**ROAD LAYOUT  
HOUSING DEVELOPMENT  
FROGSTON ROAD (POD A, SITE 1)  
EDINBURGH**

STAGE 3 ROAD SAFETY AUDIT  
(SPA Ref No: 4282)

Roads Authority: The City of Edinburgh Council

Client: Barratt Homes

13006 (PL) 002A (From Stage 2 Master Plan)

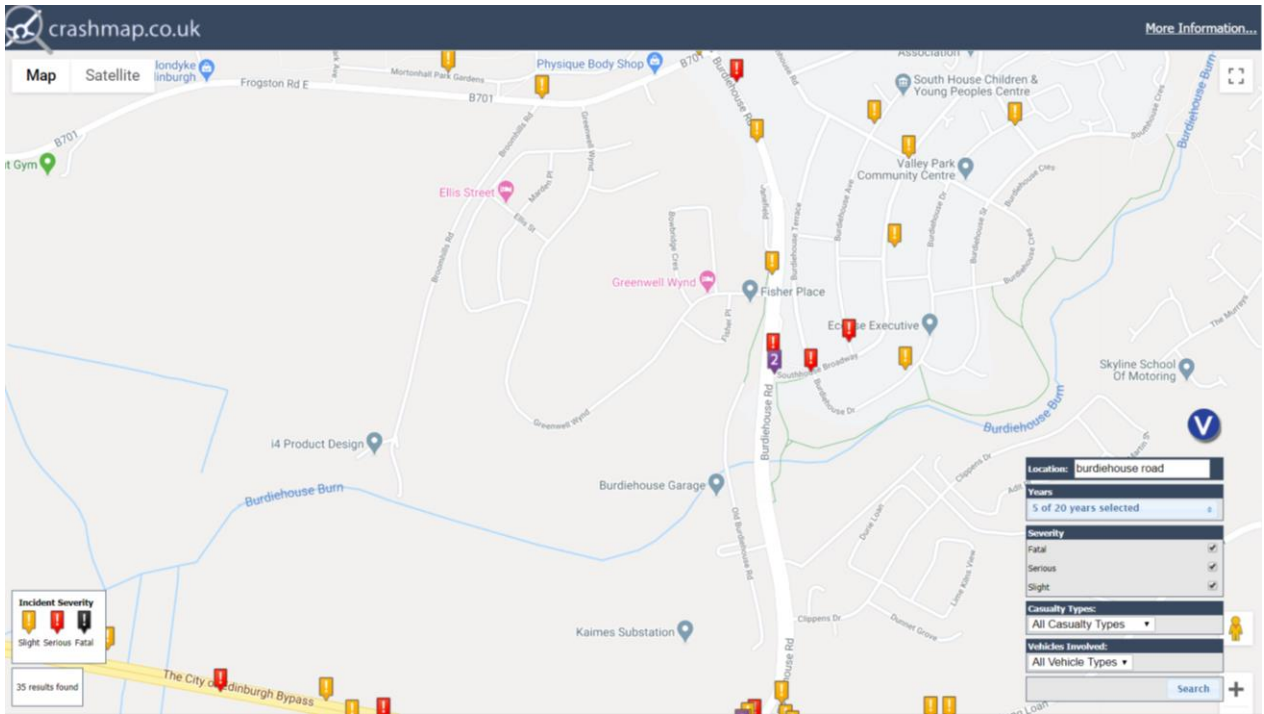
Summary: Incomplete infrastructure can lead pedestrians to and from areas where appropriate surfaces are not provided and can therefore increase the potential for slipping and tripping type accidents

It was noted that the footpath leading from Printonan Crescent to Frogston Road there is no formal surfaced footway connection or crossing point at the north end.

Summary: Missing mono-block in a shared use surface introduces a trip hazard to pedestrians.

It was noted that some mono-block units were missing at the entry to Printonan Crescent.

The Audit Team recommends that the path be closed off until appropriate connections and surfacing are provided at Frogston Road.

The Audit Team recommends that the mono-block surfacing is repaired to provide a continuous surface.

E9876~0925 [Phasing Plan RCC]

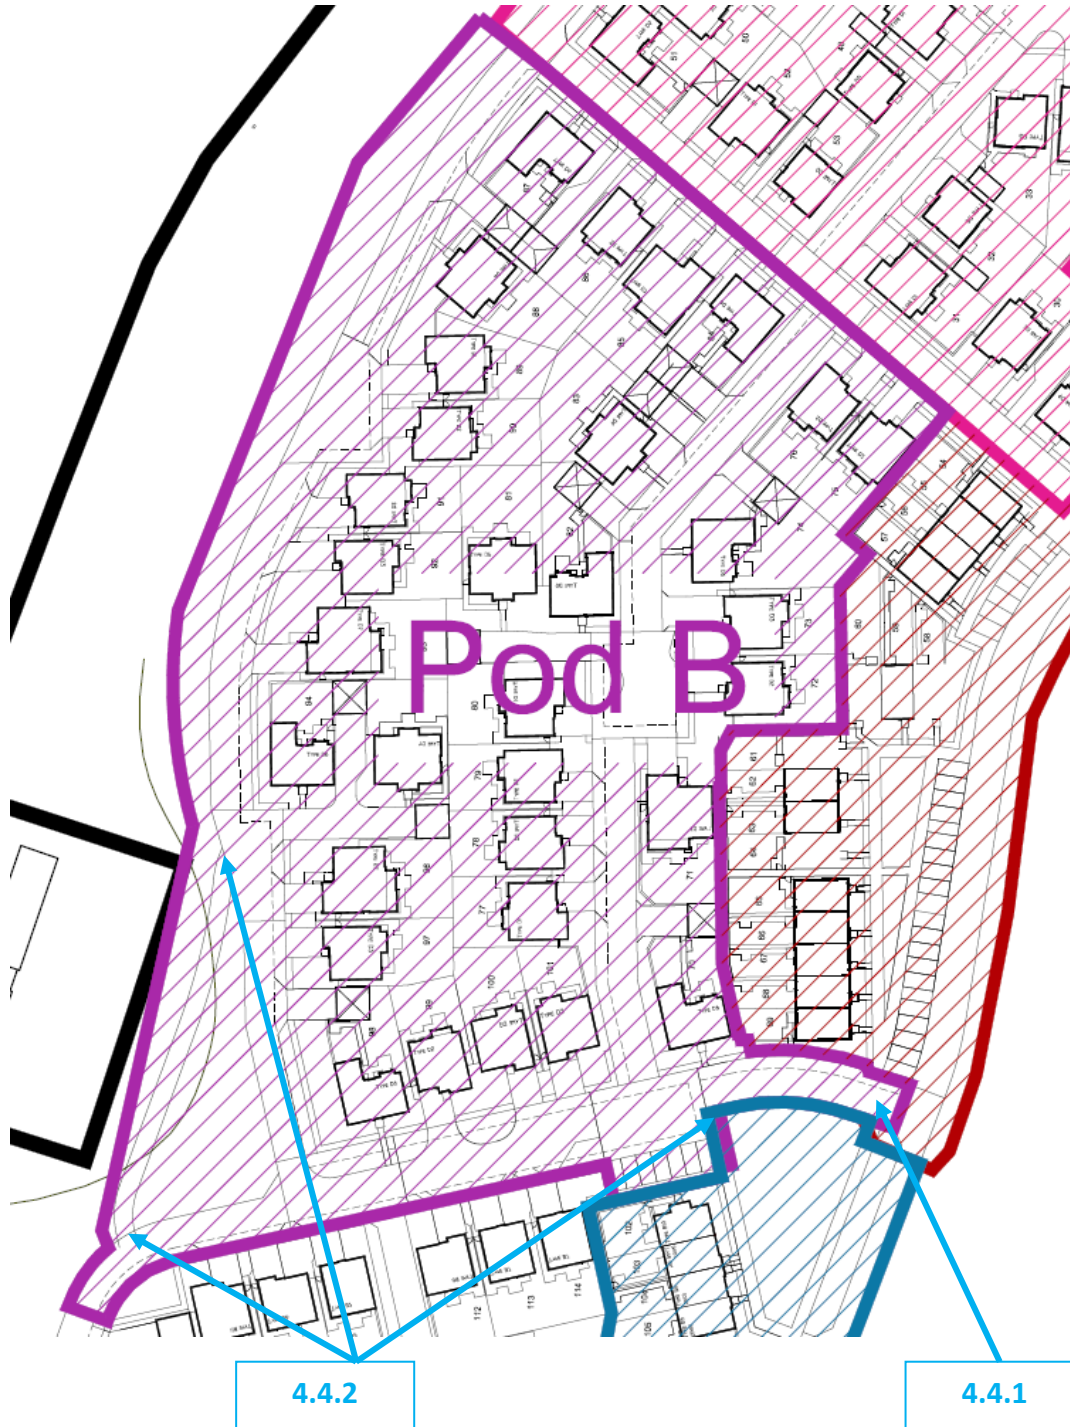
Location: Various  
Drawing(s): E9876~0925  
Summary: Uneven surfaces and gaps in paved areas can result in trip type accidents in shared space areas.

Location: Dunniker Way – East end  
Drawing(s): E9876~0925

At the east end of Dunnikier Way the footpath on the north and south of the junction did not tie-in due to being provide in an off-set manner.

Spray paint had been provided to show the potential line of north side footway to provide a crossing point that tied in with the southside footway.

The Audit Team would question if it was perhaps more practical to alter the south side footway alignment. Possibly from the lighting column northwards (See image below)

Location: Various Locations including Dunnikier Way and segregated footway on Printonan Crescent  
Drawing(s): E9876~0925

E9876~0925 [Phasing Plan RCC]

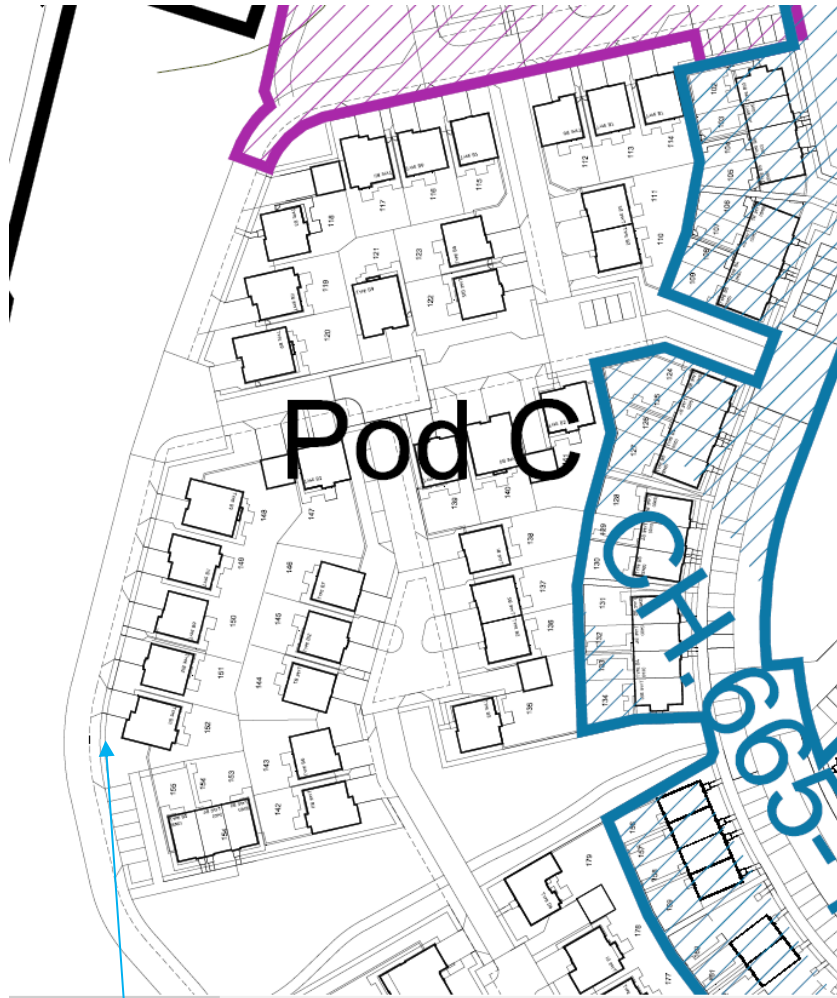
Location: Various  
Drawing(s): E9876~0925  
Summary: Ironwork sitting high in a shared surface area can be a trip hazard to pedestrians.

Location: Dunnikier Way at Plot  
Drawing(s): E9876~0925

13006 (PL) 002A (From Stage 2 Master Plan)

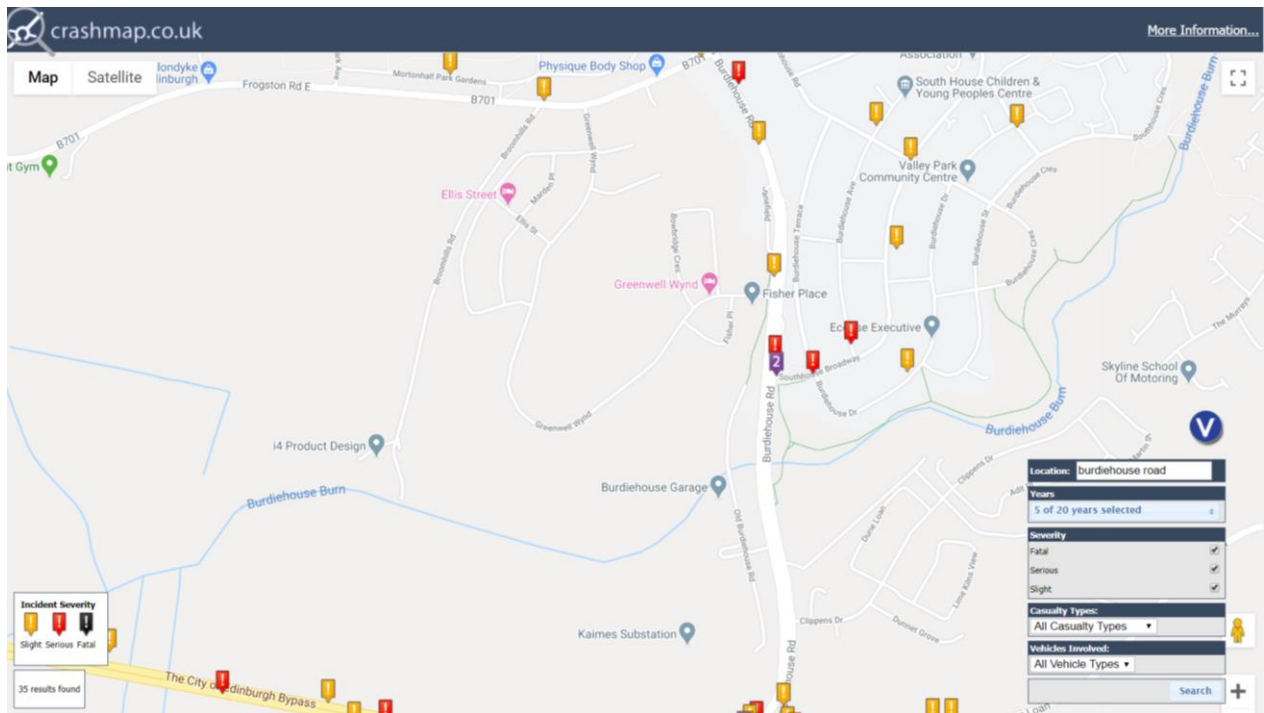
Location: Two sets of steps on the adopted footpath network on the east side of Fisher Place  
Drawing(s): 13006 (PL) 002A  
Summary: Tactile paving at steps allows users with visual impairments to identify changes in level and reduce the probability of falls.

It was noted that there were two sets of steps that had not been provided with tactile paving, at the top and bottom of the steps, to warn users of the change in level on the path network.

Location: Two locations on the footpath network to west side of Fisher Place.  
Drawing(s): 13006 (PL) 002A  
Summary:  
A lack of dropped kerbs at crossing points and transitions to shared space surfaces can increase the potential for trip type accidents.

E9876/1535 - A - Adoption Plans Pod I

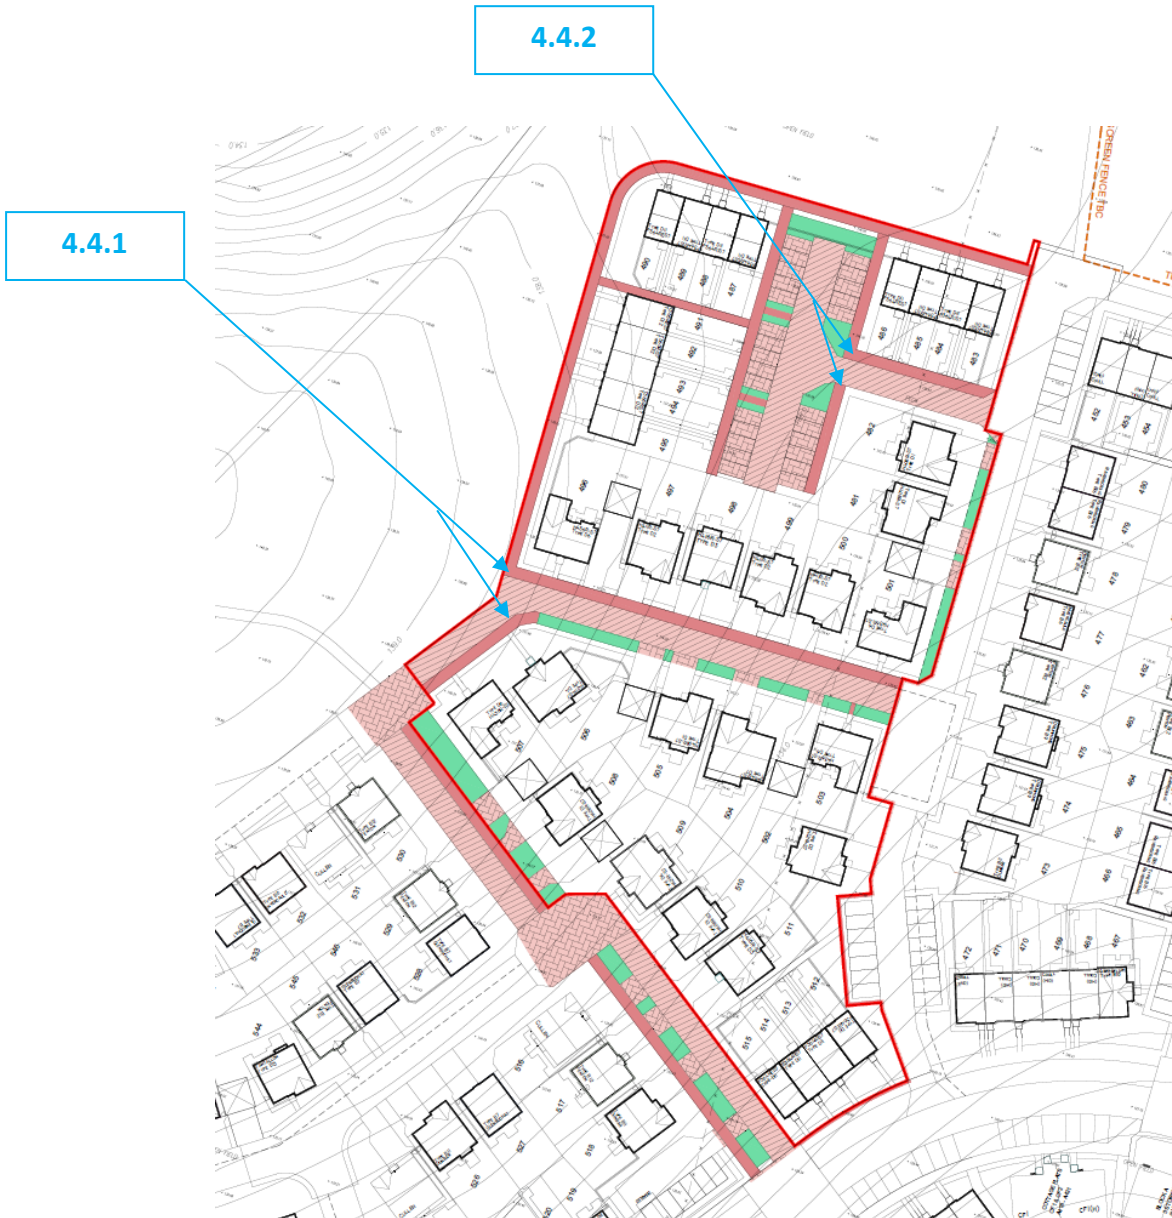
Drawing(s): E9876/1535 - A

Drawing(s): E9876/1535 - A

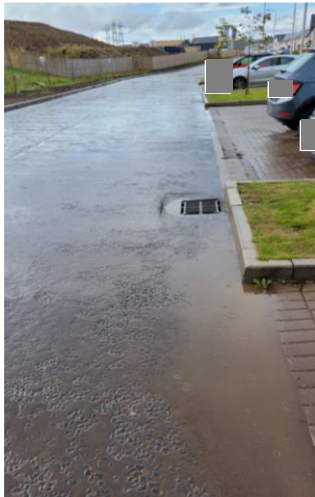
Location: Greenwell Wynd  
Drawing(s): E9876~0925  
Summary: Ponding on the carriageway can introduce skid / slip hazards to users.
